MASTER PLAN AND ZONING COMMITTEE
City of Novi Planning Commission
June 27, 2018 at 5:30 p.m.
Novi Civic Center – Police Training Center
45175 W. Ten Mile, Novi, MI 48375
(248) 347-0475
AGENDA

SUBJECT: CONSIDERATION OF PRO CONCEPT PLAN FOR LAKEVIEW

Lakeview

PLAN REVIEW CENTER REPORT

Tree Calculations East / Open Space Plan

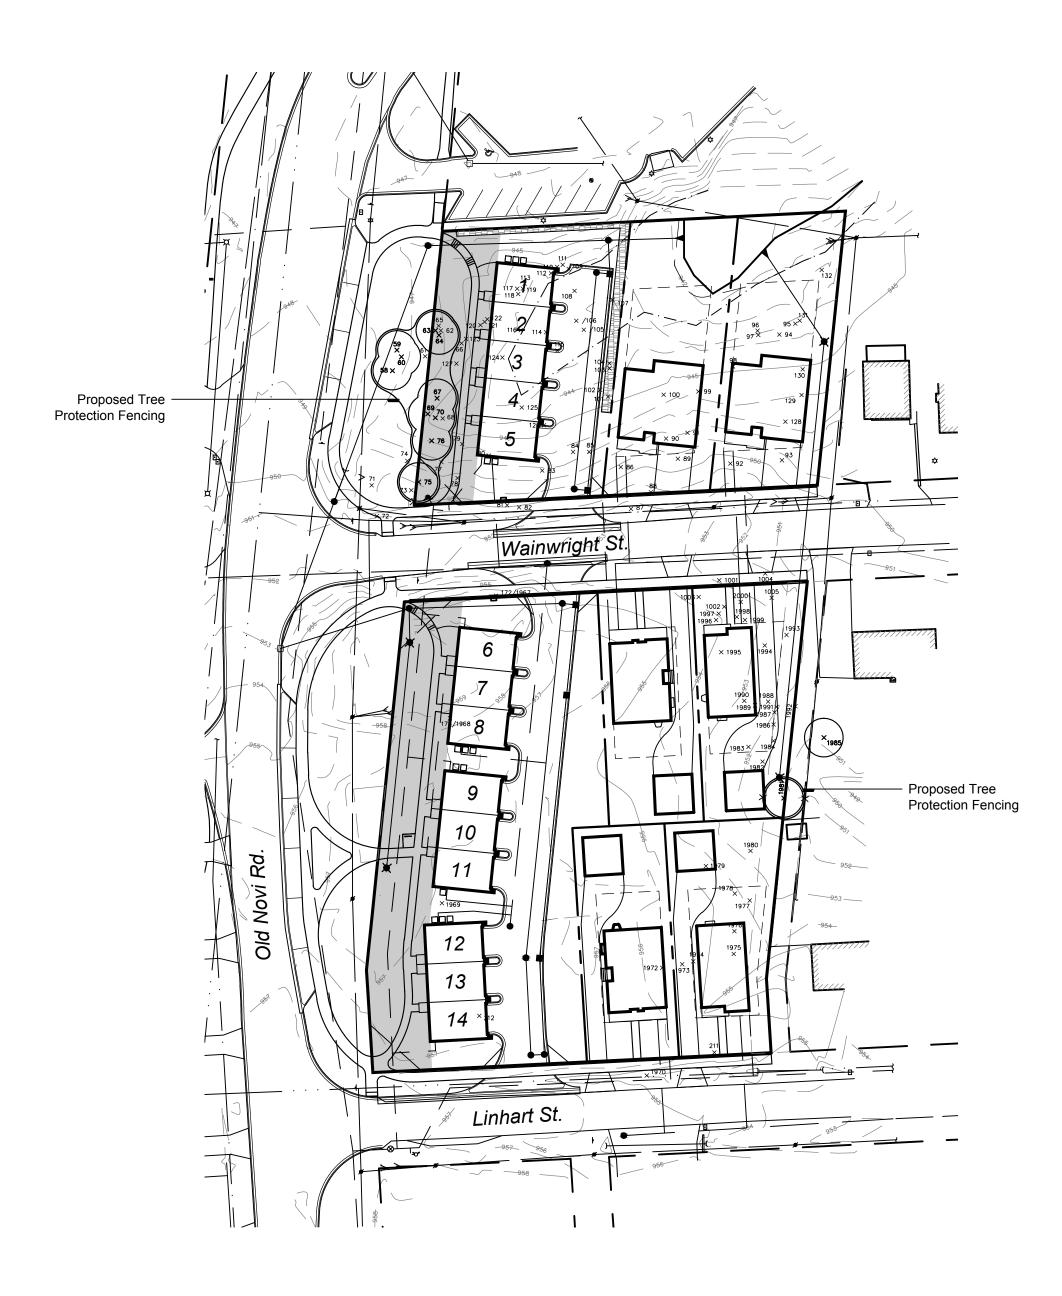
The current Plan does include a *Tree Survey* (Sheets SP4 and SP5) as well as a *Tree Inventory List* (Sheet SP5). The *Tree Inventory List* provides the Tree#, common and botanical names, diameter, condition, and comments for the surveyed, on-site trees. The Tree Calculations plans (Sheets L-2 and L-3) also contain Tree Survey information that includes the removal status of the existing trees. It should be noted that the purpose of the City of Novi Woodland Protection Ordinance (Chapter 37) is to:

Figure 1. City of Novi Regulated Wetland & Woodland Map (approximate project boundary shown in red). Regulated Woodland areas are shown in green and regulated Wetland areas are shown in blue.

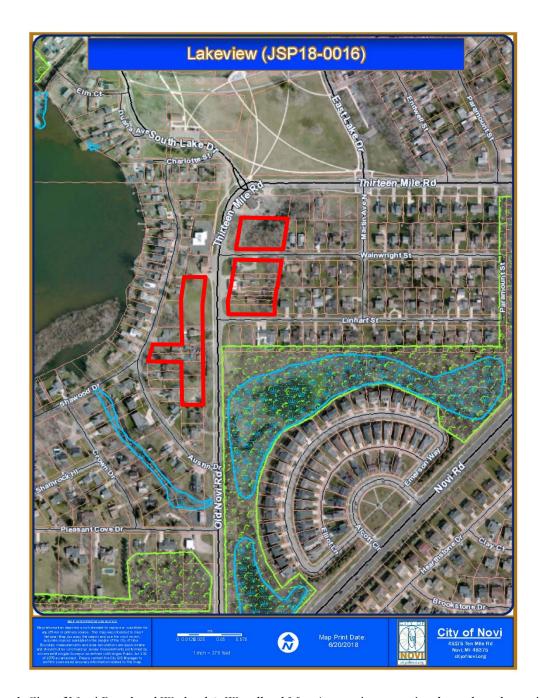
Although not indicated on the City of Novi's Regulated Wetland Map (see Figure 1), ECT identified one wetland area within the subject property at the time of the site inspection. This wetland was identified by BWA Consulting as Wetland B and wetland flag numbers are indicated as B-1 through B-14 (see Figure 2). The Plan notes that the on-site acreage of this wetland is 6,926 square feet (0.159-acre). The wetland area is an isolated forested/scrub-shrub wetland that contains an emergent depression. Vegetation observed within the wetland included silver maple (*Acer saccharinum*), cottonwood (*Populus deltoides*), box elder (*Acer negundo*), green ash (*Fraxinus pennsylvanica*), nodding beggar-ticks (*Bidens cernua*), and highbush cranberry (*Viburnum trilobum*). Surface water was present at the time of our inspection as well as-water stained leaves which are an indicator of wetland hydrology. The applicant 's wetland consultant noted that soils pits dug on-site revealed wetland (hydric) soils.

THE LAKE VIEW FIRST FLOOR

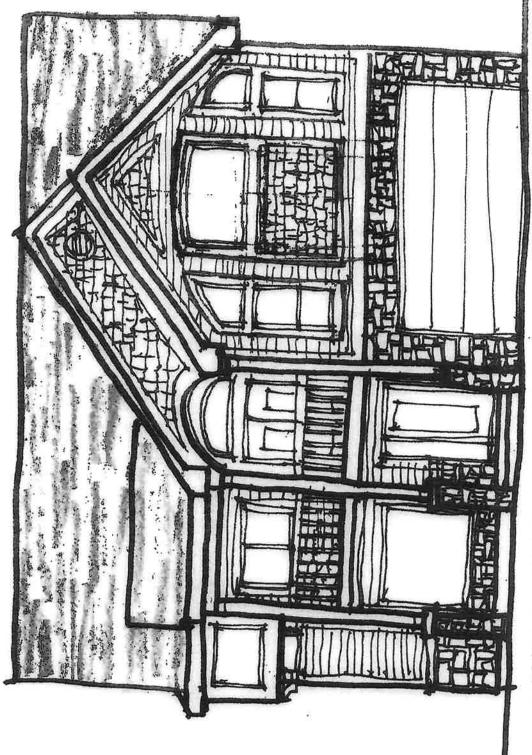
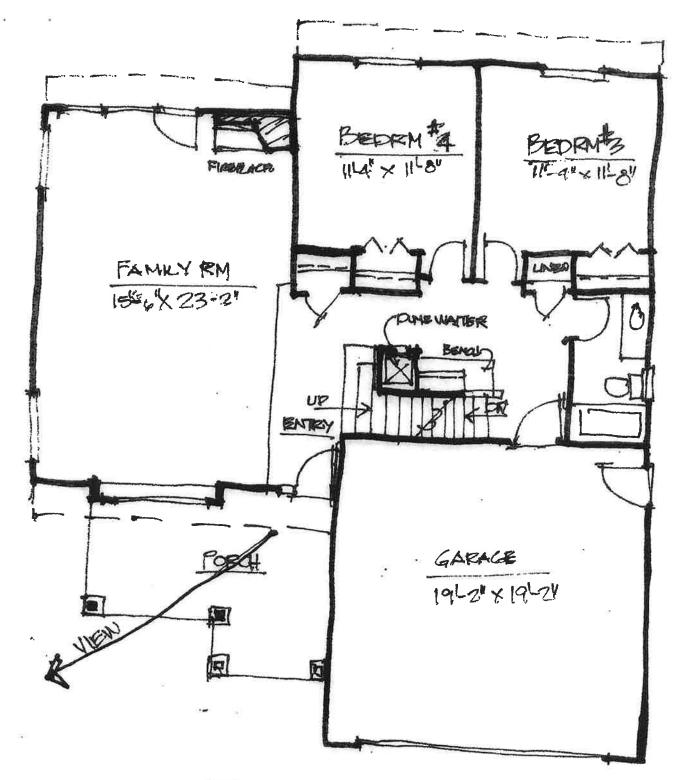
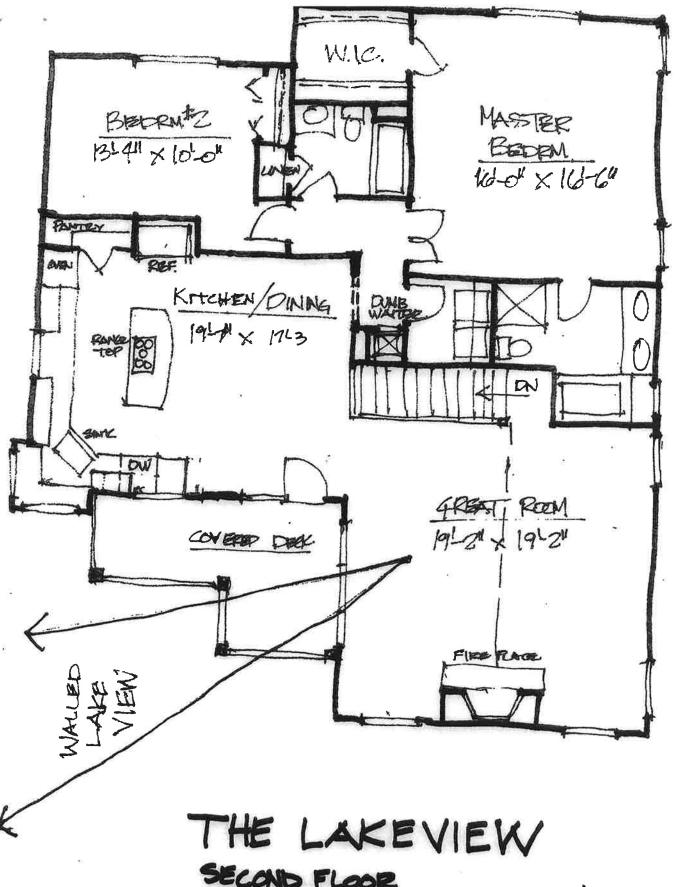
This is a benefit to the community for socialization and community culture. In exchange for the creation of this concept in extending the park down Old Novi Road with architecture created and oriented specific for the property, the community should look at this endeavor as a **benefit** to the community. Therefore, allow the Developer to build up to 25 units. Although the investment in time and money to develop new one-time unit designs specific to the property costs more, the reward in additional units and unit appeal by purchasers having a view of the water should reimburse any additional design costs.

Please see the attached single family home designed called "The Lakeview" as an example what could be developed for the property.
